Daimler Buses Recall Bulletin

Setra S417, S417TC Models
NHTSA 10V-625 & 11V-220 / TC 2010-440
TI No. 68.64U07184A

1.0 S417-S417TC PARTITION GLASS (BEHIND DRIVER'S SEAT) RECALL NOTICE

Figure 1-1 Lower Mounting Screws

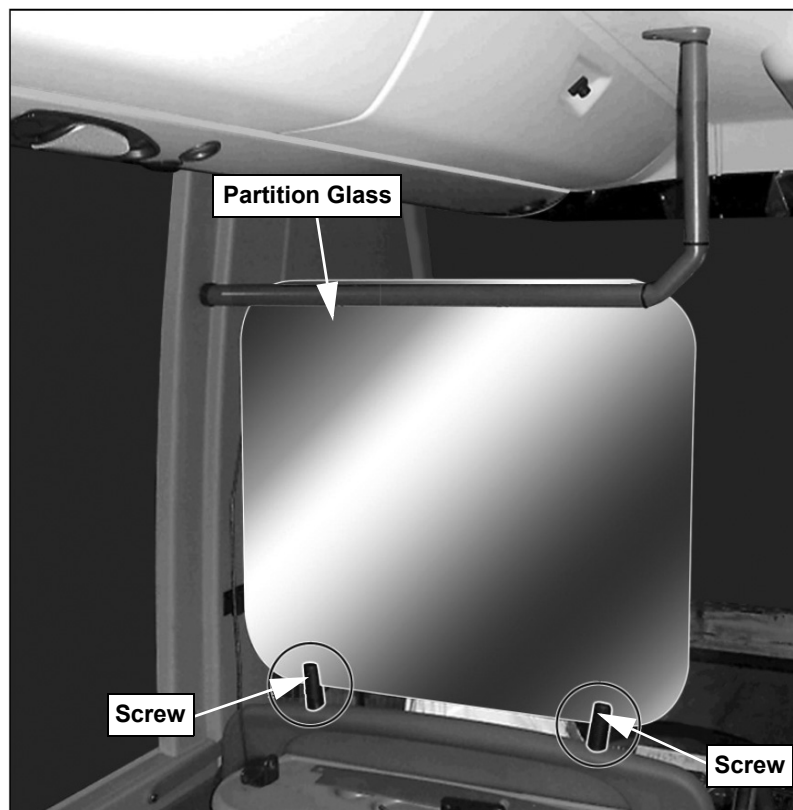
1. Remove the mounting screws and rubber washers from the lower fastening point. See [Figure 1-1](#).

1. Place replacement partition glass into position and install upper mounting screws with rubber washers. Reference [Figure 1-2](#).
2. Install the lower mounting screws with rubber washers. Reference [Figure 1-1](#).

Figure 1-2 Upper Mounting Screws

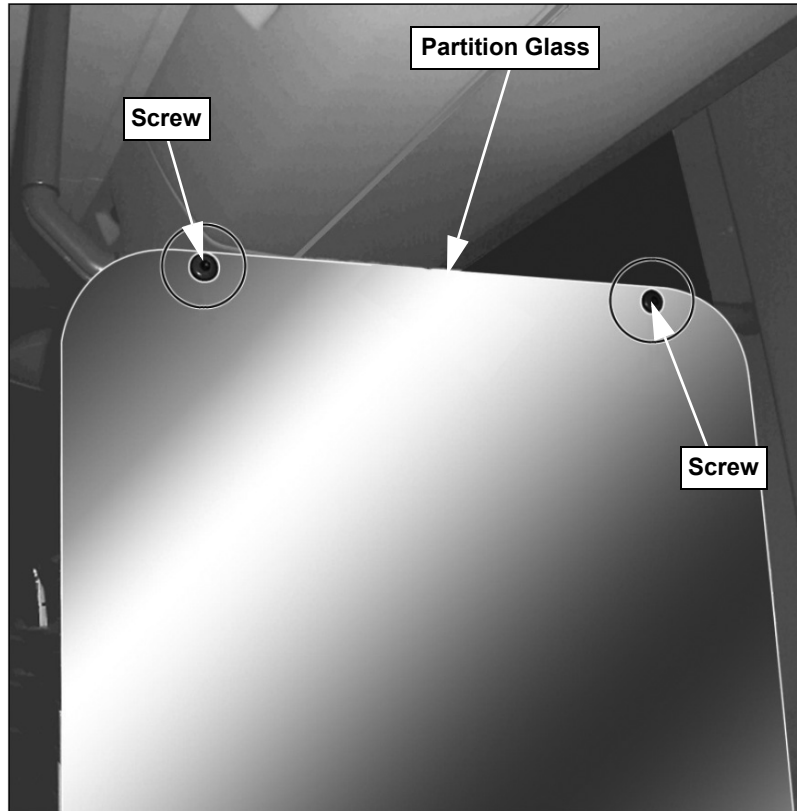
2. Remove the upper screws and rubber washers from the lower upper point and remove the partition glass. See [Figure 1-2](#).
